ECE/TRANS/WP.29/GRE/2008/19  
18 January 2008

REGULATION No. 37  
(Filament lamps)

Proposal for Supplement 32 to the 03 series of amendments to Regulation No. 37 \*/

Submitted by the expert from the Working Party "Brussels 1952" (GTB)

**CATEGORIES PC16W, PCY16W AND PCR16W** **Sheet PC16W/1**

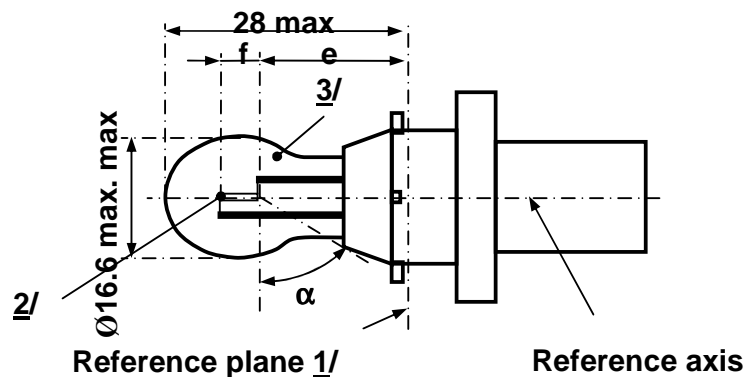
Insert new sheets PC16W/1 to 3, between sheet P27/7W/3 and sheet PR21W/1, to read:

- 1/ The reference plane is defined by the meeting points of the cap-holder fit.
- 2/ No actual filament diameter restrictions apply but the objective is  $d \text{ max.} = 1.1 \text{ mm}$ .
- 3/ The light emitted from normal production lamps shall be white for category PC16W; amber for category PCY16W; red for category PCR16W. (see also note 7/).

## Sheet PC16W/2

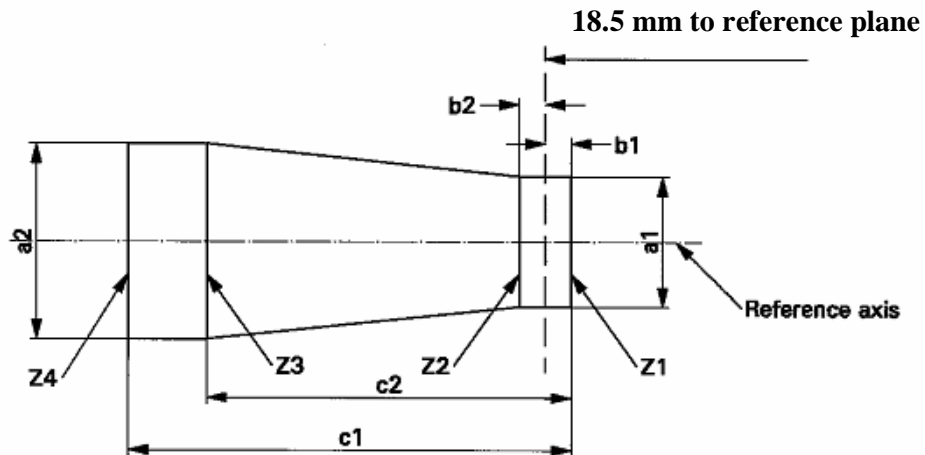
Dimensions in mm		Filament lamps of normal production			Standard filament lamp
		min.	nom.	max.	<u>7/</u>
e	<u>4/</u> <u>5/</u>		18.5		18.5
f	4/ 5/		4.0		4.0 ± 0.2
α	6/	54°			54° min.
PC16W Cap PU20d-1 PCY16W Cap PU20d-2 PCR16W Cap PU20d-7	in accordance with IEC Publication 60061 (sheet 7004-[...]-1)				
ELECTRICAL AND PHOTOMETRIC CHARACTERISTICS					
Rated values	Volts	12			12
	Watts	16			16
Test voltage	Volts	13.5			13.5
Objective values	Watts	17 max.			17 max.
	Luminous flux	PC16W	300 ± 15 per cent		
		PCY16W	180 ± 20 per cent		
		PCR16W	70 ± 20 per cent		
Reference luminous flux at approximately			13.5 V	White: 300 lm Amber: 180 lm Red: 70 lm

- 4/ The filament position is checked by means of a "Box-System"; sheet PC16W/3.
- 5/ The ends of the filament are defined as the points where, when the viewing direction is perpendicular to the plane through the filament lead-in wires as showed in the drawing on sheet PC16W/1, the projection of the outside of the end turns crosses the filament axis.
- 6/ No part of the cap beyond the reference plane shall interfere with angle α. The bulb shall be optically distortion free within the angle 2α + 180°.
- 7/ The light emitted from standard filament lamps shall be white for category PC16W; white or amber for category PCY16W; white or red for category PCR16W.
